ICHD - ENVIRONMENTAL HEALTH DIVISION

SEPTIC: IMPROVEMENT PERMIT / AUTHORIZATION TO CONSTRUCT / OPERATION PERMIT / EXISTING SYSTEM

PERMIT # OSWP-2022-8477

Artisan Custom Homes
Murphy Residence WWTS

AS BUILT SKETCH

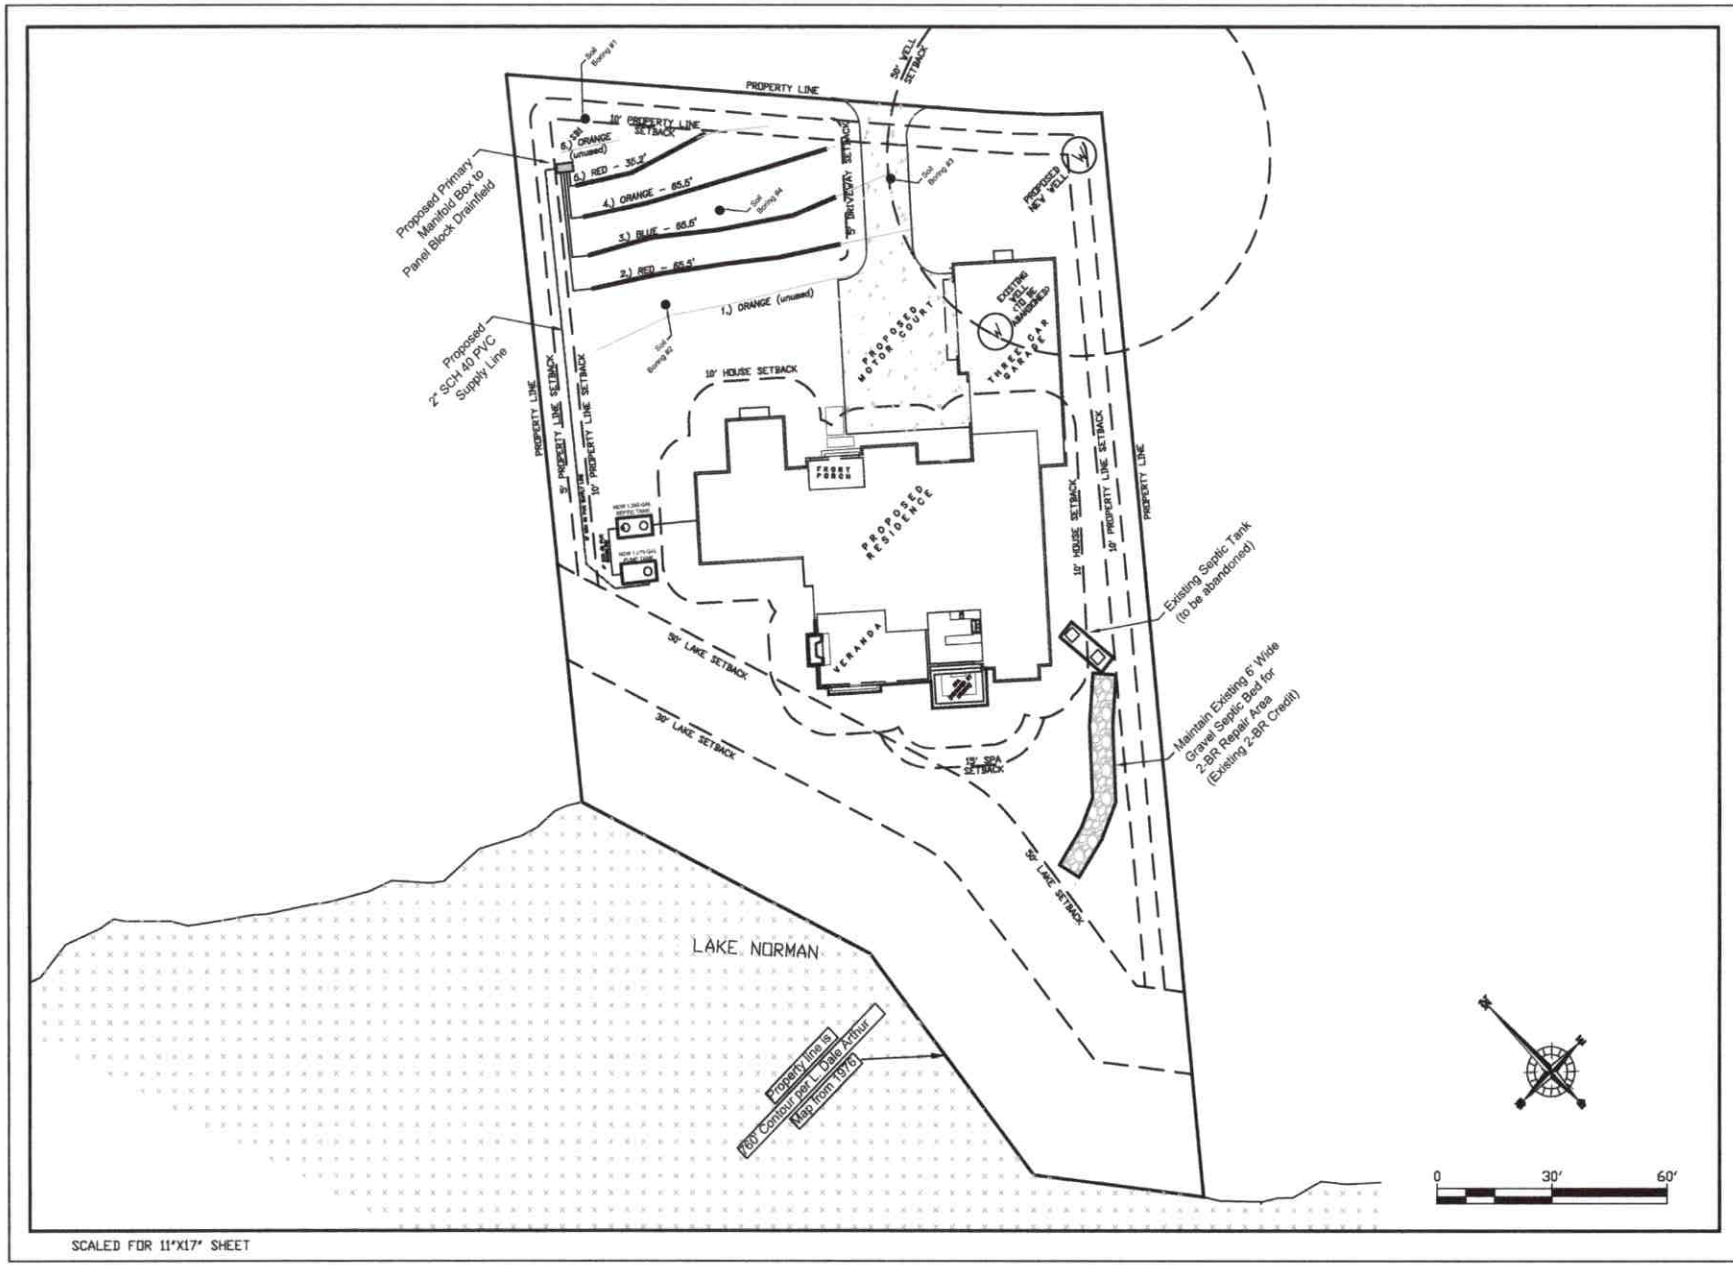
Irrigation cut & capped - not functioning at time of final. Reconnection w/ any lines. <10 from septic will be a violation

Alarm did not on Irrigation by septic line

Electrical not on separate breakers or split between Alarm & Pump. MW.

Determination of Dose Volume - Primary System

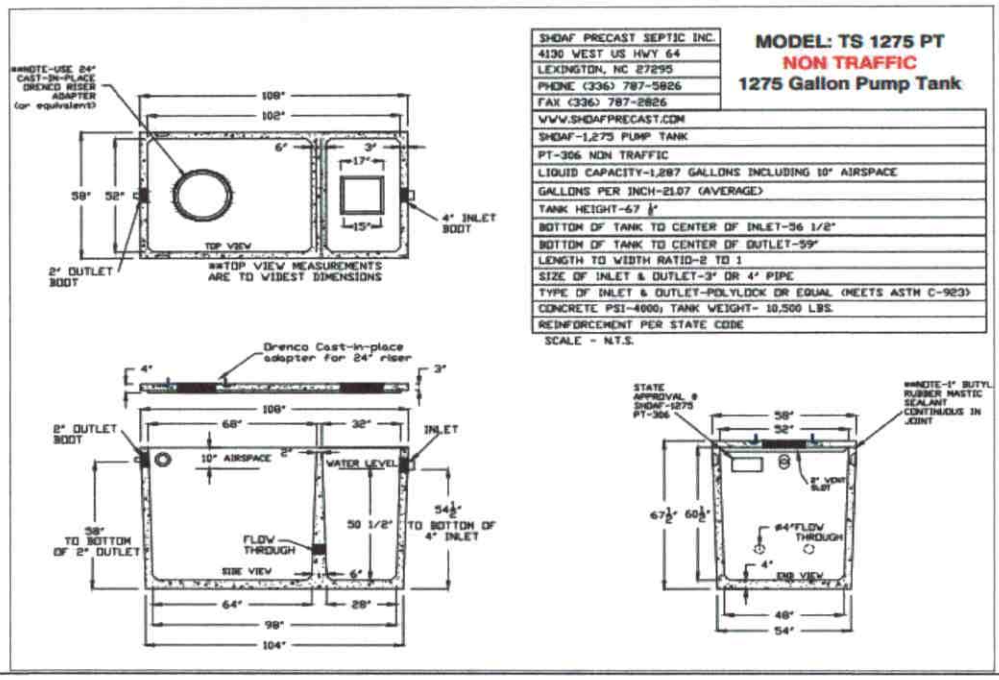
☒ Denied (See attached report.) Need: well abandoned, floor plans, PM design correction

Total Run Time	10.06	min
Volume per Panel	5.76	gal → 3.69
Number of Panels	53	
Dose Volume	305	gal/dose
Runtime/Dose (min)	8.53	min
Volume/depth	20.16	gal/in
Estimated Drawdown	15.14	in

Please correct dose, drawdown, runtime.

Total Run Time	10.06	min
Volume per Panel	3.60	gal
Number of Panels	53	
Dose Volume	191	gal/dose
Runtime/Dose (min)	5.33	min
Volume/depth	20.16	gal/in
Estimated Drawdown	9.46	in

SHEET TITLE
Property Layout

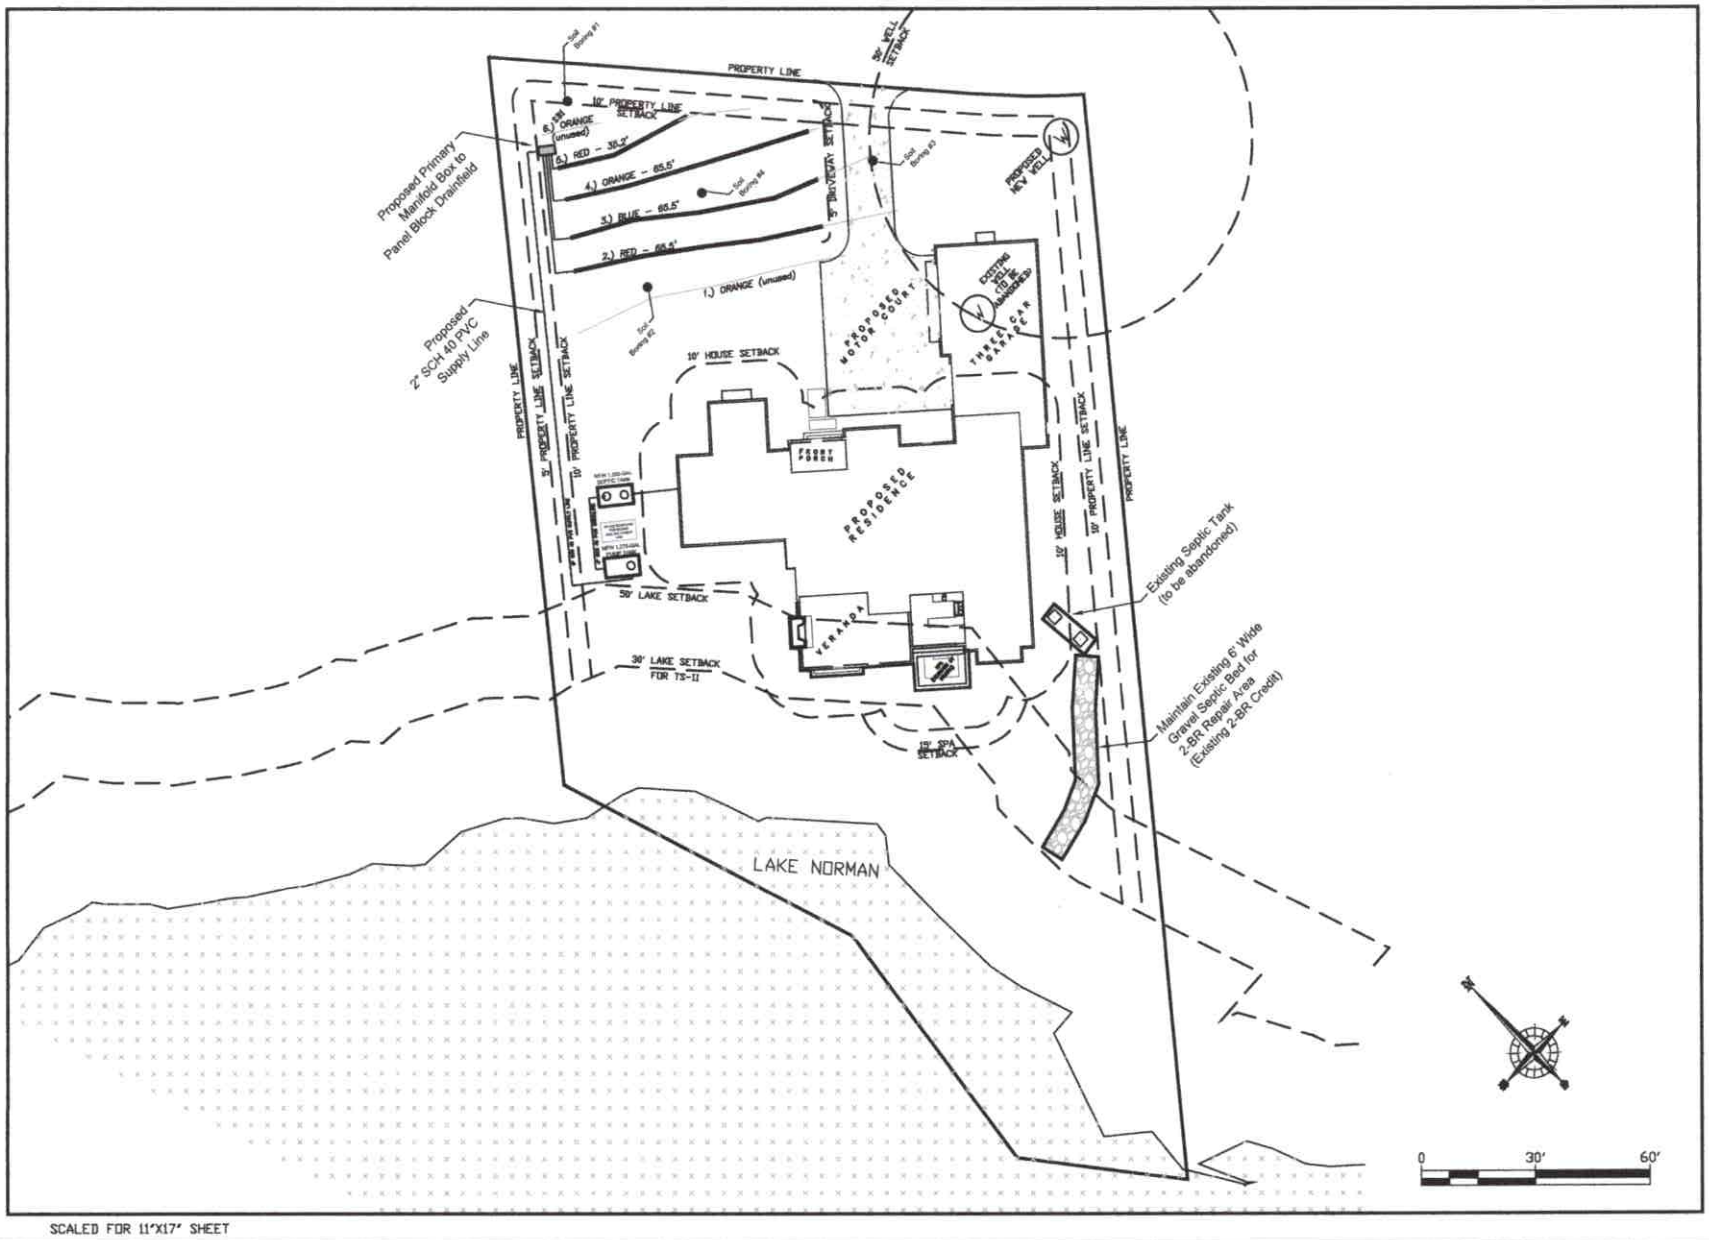
1) Current site plan shows house in the buffer - update site plan in septic permit packet.

REV.	ISSUED DATE	DESCRIPTION
1.)	11/22/22	Revised Setbacks
